FORD AODE/4R70W VALVE BODY AND SPACER PLATE IDENTIFICATION

Figure 1

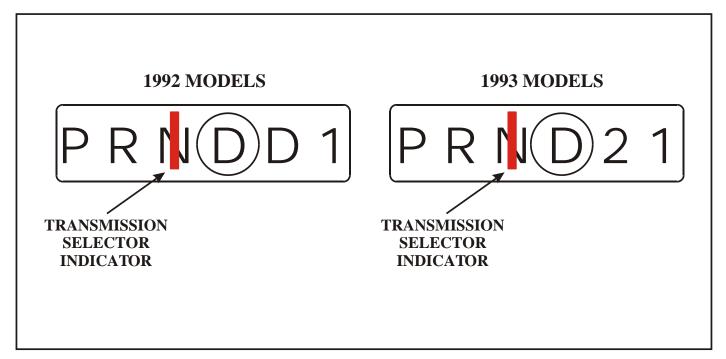
Both the 1992 and 1993 shift selectors have six positions, but their functions are different, as shown in Figure 1. On 1993 models the "2" position replaces the "D" position, and now provides second gear start and hold. This position can be selected when starting on slippery roads for improved traction, or engine braking. This changed both the valve body and spacer plate between 92 and 93 models and, THEY WILL NOT INTERCHANGE!

Figure 2

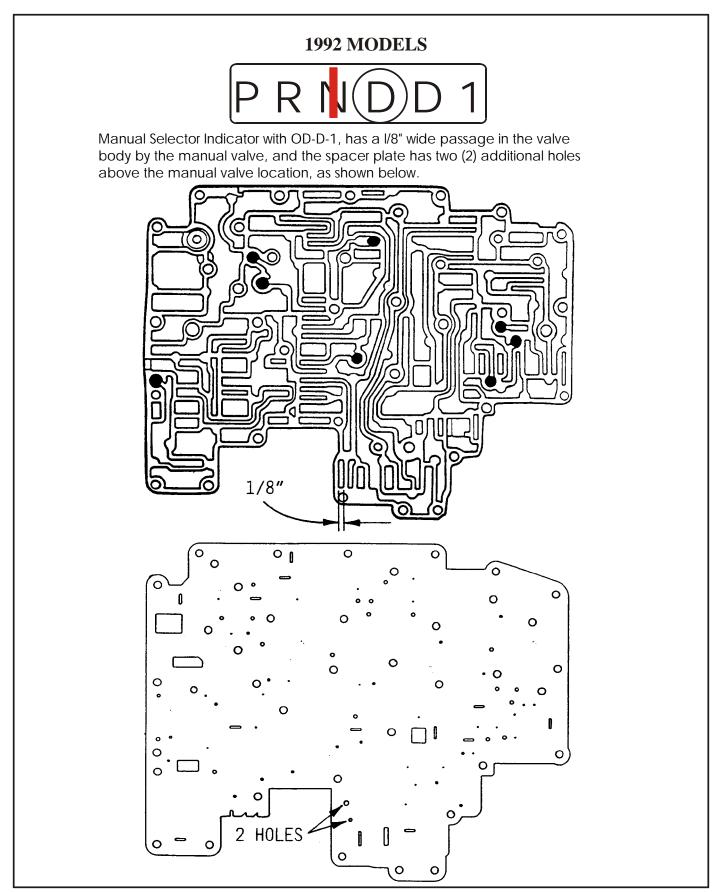
If a 1993 valve body and spacer plate are installed onto a 1992 model vehicle, you will have 2nd gear only with the selector lever in the "D" position. If a 1992 valve body and spacer plate are installed onto a 1993 model vehicle, you will have a 1-2-3 upshift when the selector lever is in the "2" position, and the overdrive cancel switch will be ineffective. Refer to Figure 4 for Transmission Control Switch (TCS) and Transmission Control Indicator Lamp (TCIL) locations for the various 1993 model vehicles equipped with the AODE/4R70W transmission.

Refer to Figure 2 for 1992 model valve body and spacer plate identification, and refer to Figure 3 for 1993 model valve body and spacer plate identification.
